Holcim - WCR, Inc.

Lyons Quarry

File #: M-1977-141

112c Reclamation Permit Operations
Technical Revision

Figure 8 – Rockfall Catchment Basins and Berms, (Attachment E-2, Figure 1)

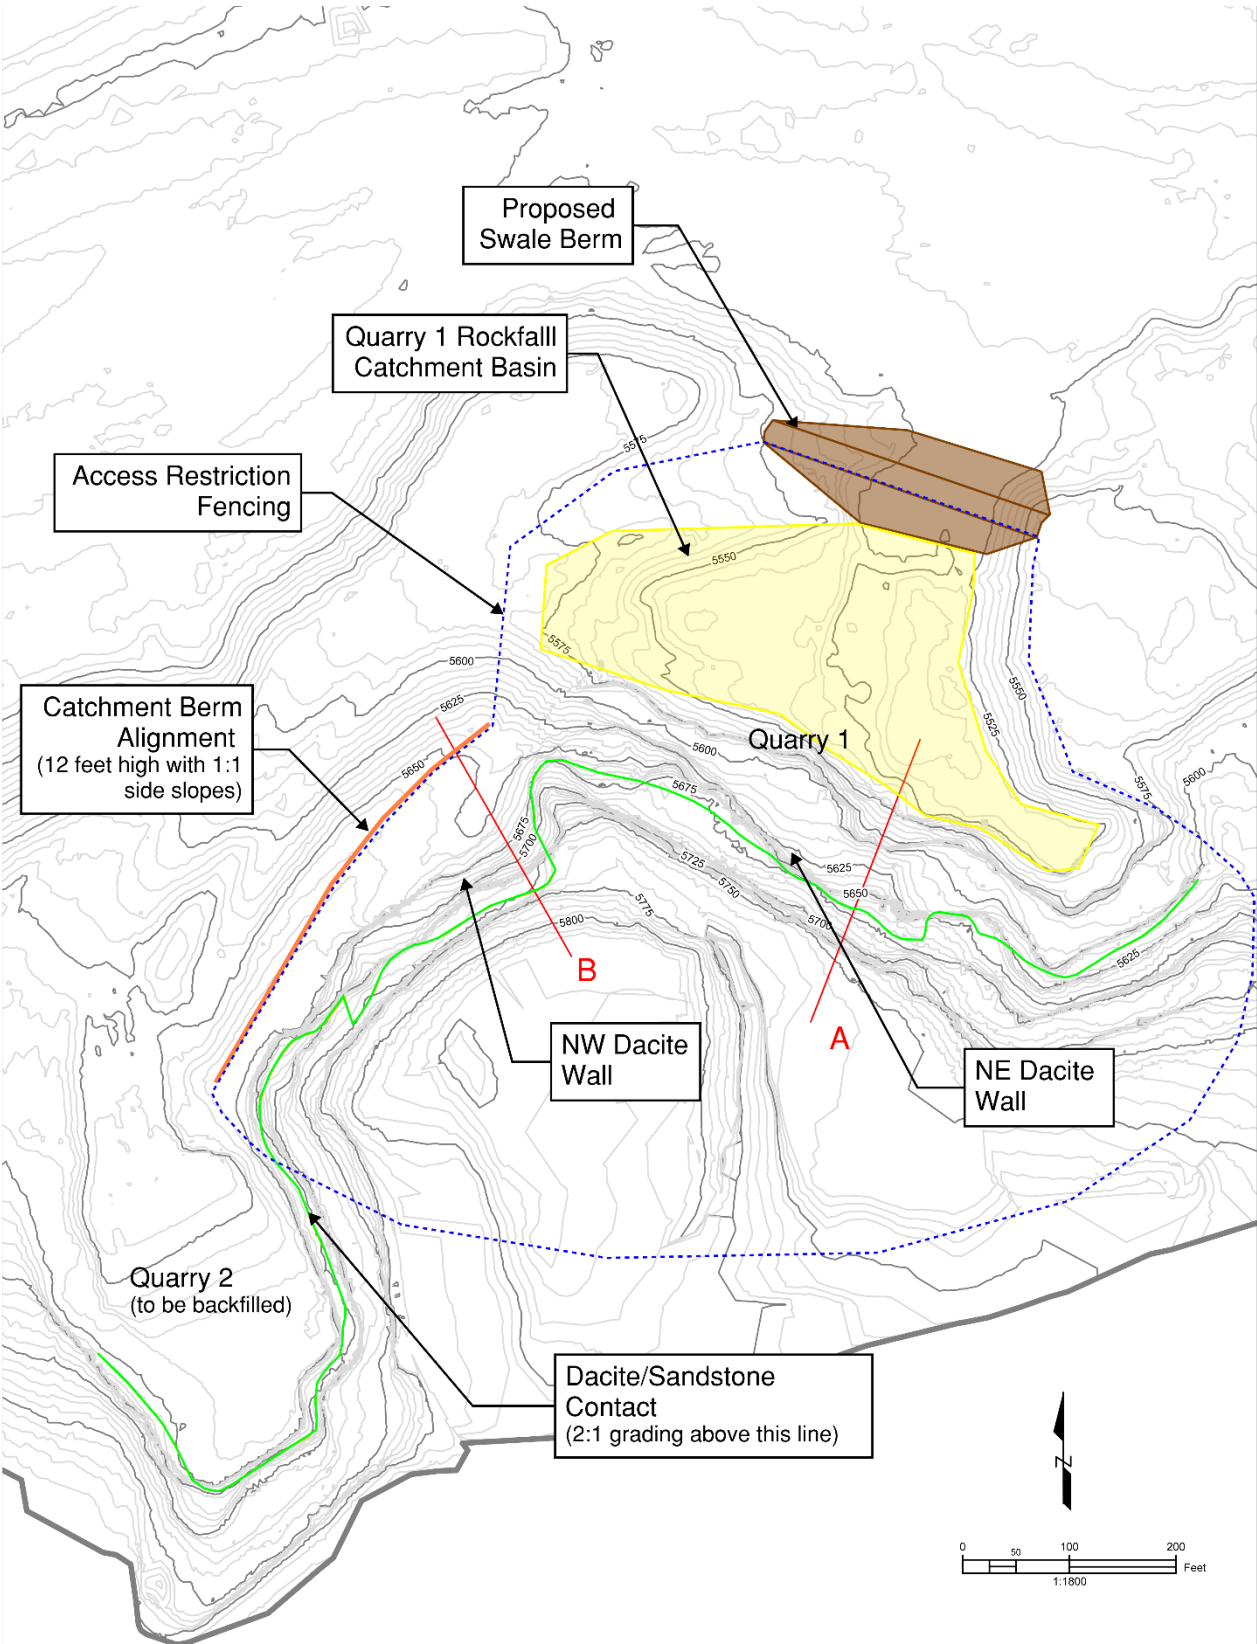
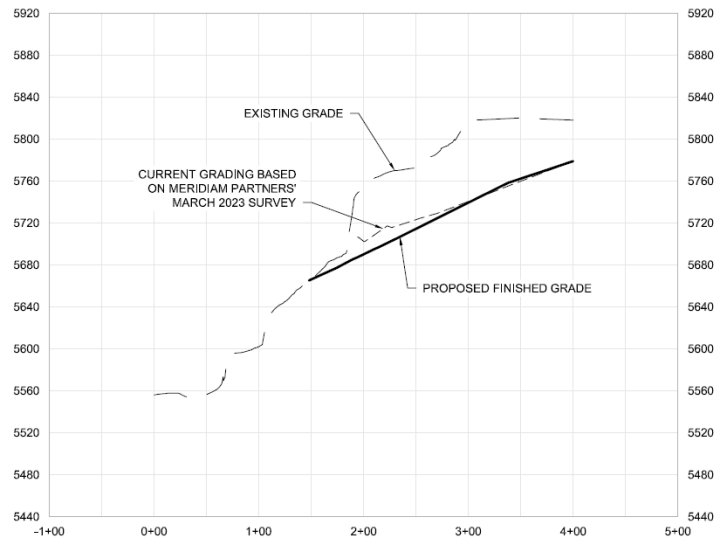
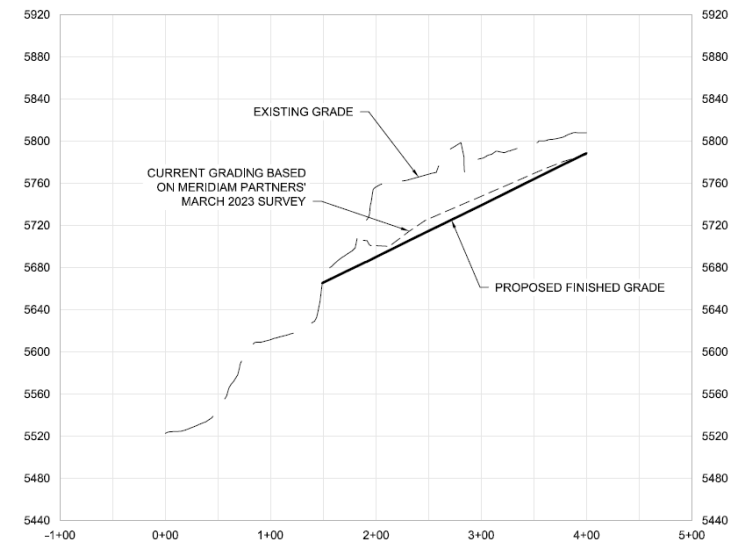
Based on the recommendations above and inherent safety issues that limit safe access the highwall face to install ground controls, it is proposed that the Ground Controls included in TR-05 be removed from the reclamation plan. The rockfall catchment berms designed under TR-05 have been installed to specifications with only minor deviations in the placement of the northwest catchment berm based on slope configurations. The geotechnical engineers reviewed the as-built files for this catchment berm and included its placement into the modeling for the analyses.

Figure 9 – Quarry 2 Fill Current Grading

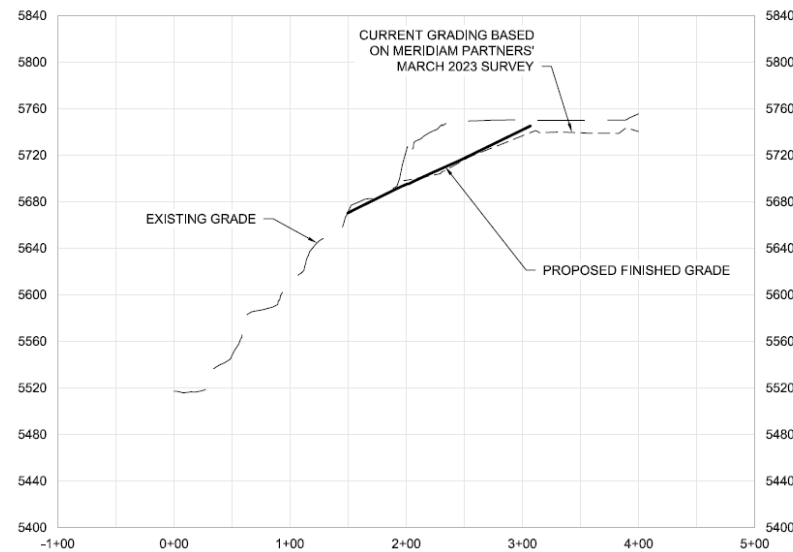
As shown in Figure 9, the fill slopes of Quarry 2 were graded from the top down. Following placement of fill, the configuration of the Quarry 2 slopes was shallower and more stable than the TR-05 grading plan which calls for 2H:1V slopes and benches every 50 vertical feet. Because the material was placed in this area from the top down there exists an excess of fill. Slope configurations ranged between 2.7H:1V and 4.3H:1V as shown in Sheet 01C-02 of the grading plans.

Holcim proposed to BCPOS to revise the grading plan for the Quarry 2 Fill and raise the invert of the drainage channel in place of removing, hauling and replacing this material. The drainage channel through Quarry 2 remained at the same slope of approximately 20% as designed, but the invert elevation was raised roughly 15-20 feet and additional fill was placed at the north end of quarry to tie the drainage into downgradient slopes. The remaining excess material was pulled out and placed for the catchment berms on the northeast and northwest faces of the highwall.

BCPOS has approved this revision as the flatter slopes will reduce the likelihood of erosion and allow for maintenance equipment to traverse the majority of the slopes at the west end of the site.
